**SECURE DOCUMENT STORAGE FACILITY
BAGHDAD, IRAQ**

SUSTAINMENT ASSESSMENT

**SIGIR PA-08-166
OCTOBER 20, 2009**

Figure 1. Strengthening columns

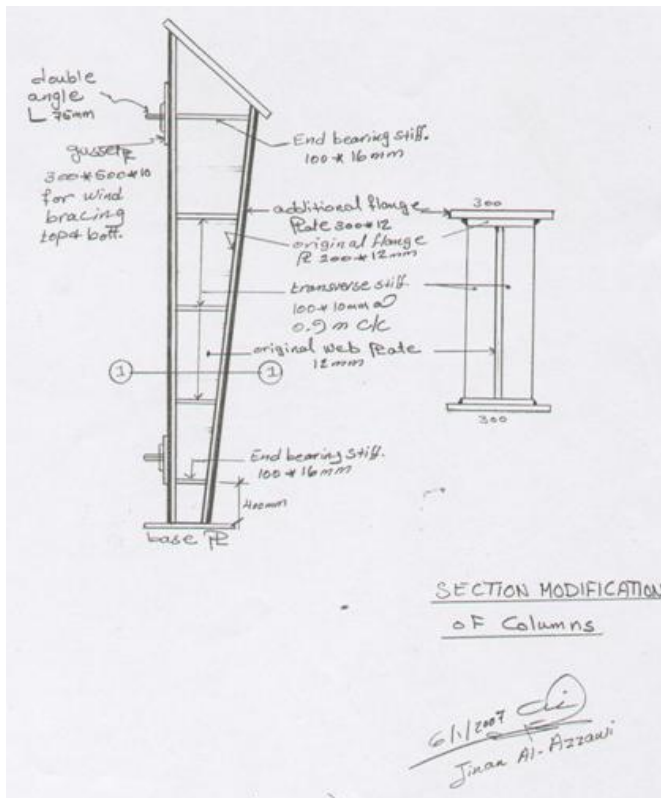
SIGIR reviewed the contractor's initial design. It appeared that the contractor failed to coordinate the design information with the drawings released for construction, which resulted in at least two significant omissions contributing to the initial failure of the structure and the subsequent need for reinforcing:

1. The original design calculations indicate that the center of the frame was to be supported with a column, but the contractor's original drawings omit any support at the center of the frame.
2. The design calculations for the steel frame make the assumption that there is no moment transfer⁸ between the steel column base and the reinforced-concrete pedestal. This configuration is typical for moment frame⁹ construction; however,

restraint of the column bases must be provided. The foundation details do not provide any method for lateral restraint.

In addition, no provision was made for lateral stability of the structure in the longitudinal axis. Concrete masonry unit (CMU) walls were constructed between the proposed columns; if properly constructed, the CMU walls could have been used as a lateral-load resisting mechanism (shear wall). However, because this issue was neglected during the design of the facility, no provisions were made during construction to utilize the wall, and no load-resisting system was provided later with the initial construction.

SIGIR also identified an issue with the load criteria for the project. In a review of the contractor's engineering design calculations, GRC identified issues with the original design loads for the building. The original design live load¹⁰ for the building was set at 5 pounds per square foot (psf). The design engineer justified this design load by incorrectly categorizing the structure as "fabric construction supported by a light weight rigid skeleton structure." The correct design load for this type of structure, as identified by GRC, is 20 psf. The increase in live load by a factor of four would significantly affect the design of the structure.

After the December 2006 structural failure, the contractor performed an evaluation and proposed a revised design in January 2007. Specifically, the contractor proposed reinforcing the structure to accommodate the design deficiencies. The proposed solution consisted of the following:

- adding coverplates and stiffeners to the steel frame (Figure 1)
- placing collar ties at each frame
- adding an additional column at the center of each frame
- providing a lateral-load resisting system for the structure (Figure 2)

Figure 3. Three-dimensional model of contractor-proposed improvements (Courtesy of GRC)

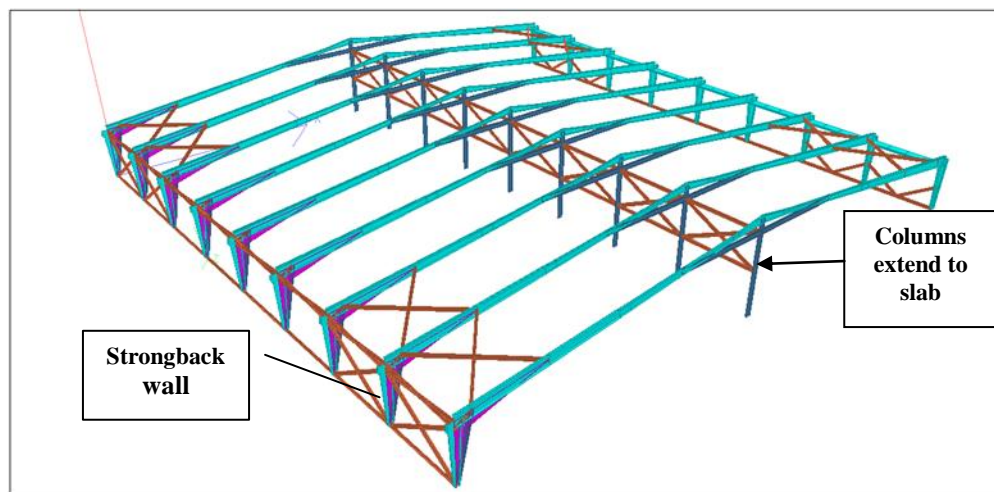
Figure 3 illustrates the proposed new steel columns along the centerline, extending to the floor. However, by this time, the interior vault rooms had already been constructed, including a reinforced-concrete beam and partition wall running the length of the building, beneath the centerline of the steel frames. Based upon review of the October 2007 QA reports, it appeared that the contractor performed a modified approach to placing the columns. A base plate was placed on the top of the reinforced-concrete beam, and the columns were welded to the base plate (Site Photo 3). Consequently, this model and corresponding structural analysis do not account for the additional load to the reinforced-concrete beam, supporting columns, and foundation.

The contractor provided a revised design submittal in January 2007 to correct the design deficiencies that led to the structural failure. In July 2007, the GRC quality assurance (QA) representative documented examples of the building not being constructed in accordance with the planned structural improvements of January 2007. On 26 July 2007, a GRC structural engineer performed an inspection of the construction to date. The GRC structural engineer issued an observation report, which identified several construction deficiencies; all structural work again stopped while the contractor performed another structural evaluation. In September 2007, the contractor presented GRC with structural improvements, including a structural analysis indicating that the proposed improvements would provide a stable structure under eight different loading conditions. The proposal included a row of columns to be constructed along the centerline of the facility, as well as other strengthening improvements, such as corner bracing, cross bracing, and a strongback¹³ wall (Figure 3).

Figure 4. Poured concrete columns within block wall (Courtesy of GRC)

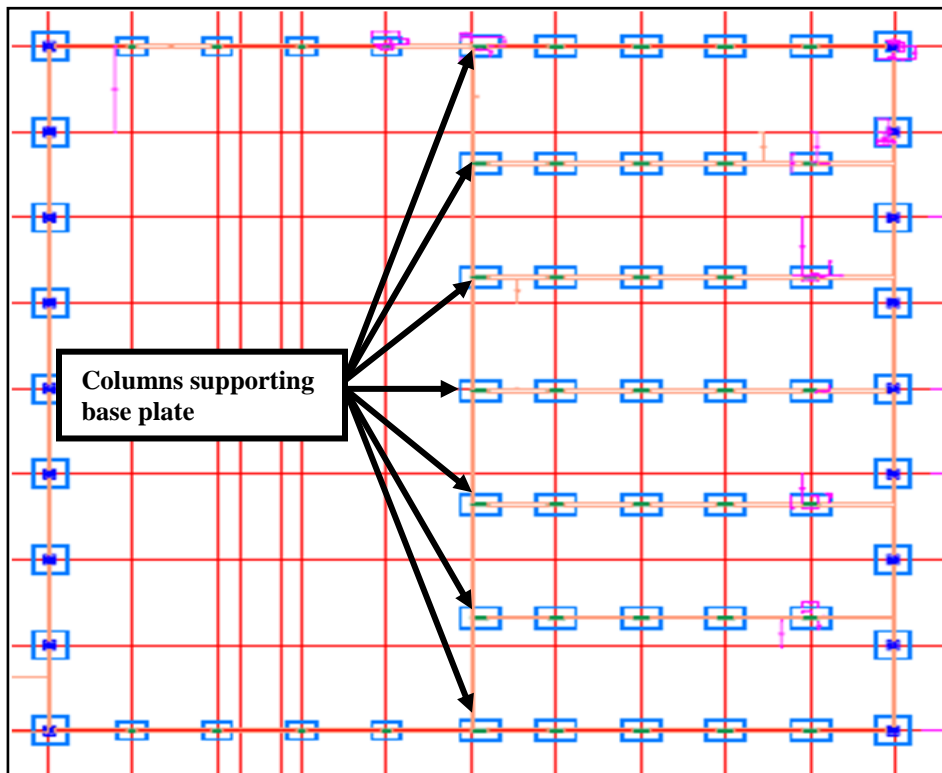
A concrete masonry partition wall is located beneath the reinforced-concrete beam (Figure 4). If the reinforced-concrete beam deflects under load, some load sharing between the beam and the wall will occur. Reviewing the daily QA reports, SIGIR identified that the blocks used to create this wall were of poor quality, which by themselves, would be of questionable capacity to hold any significant load. The presence

of the beam indicates that the original designer did not anticipate the wall to be a structural element.

**Site Photo 15. Contractor replaced previously cracked and buckling floor tiles
(See Site Photo 8 for original condition of bathroom floor.)**

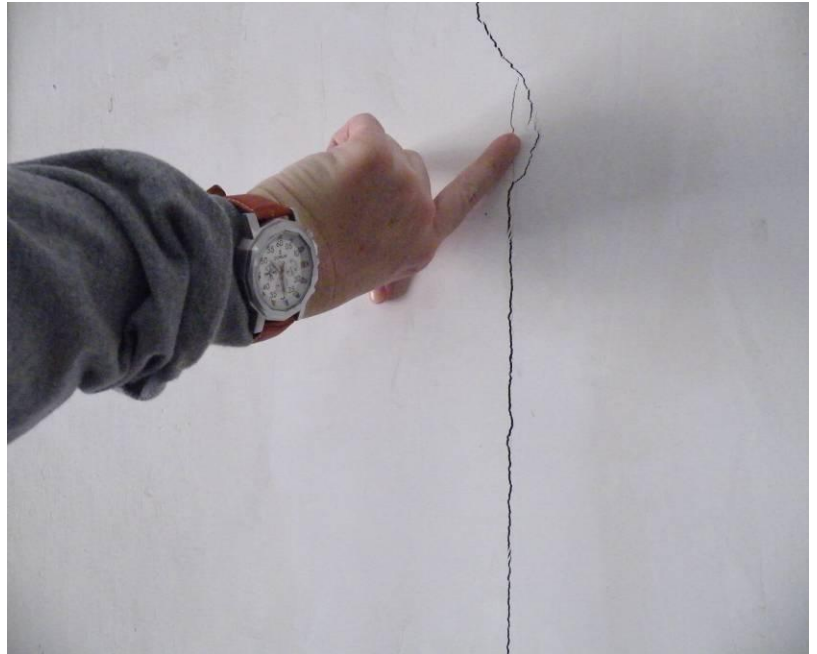
Site Photo 8. Example of tile cracking and buckling inside SDSF latrine

However, during the 27 September 2009 site visit, SIGIR toured the entire facility and determined that the contractor had remedied the previously identified warranty deficiencies (Site Photo 15). The SDSF facility manager stated that the GRC IZ Resident Office did an excellent job of requiring the contractor to return to the facility three times to ensure that each warranty issue was adequately addressed.
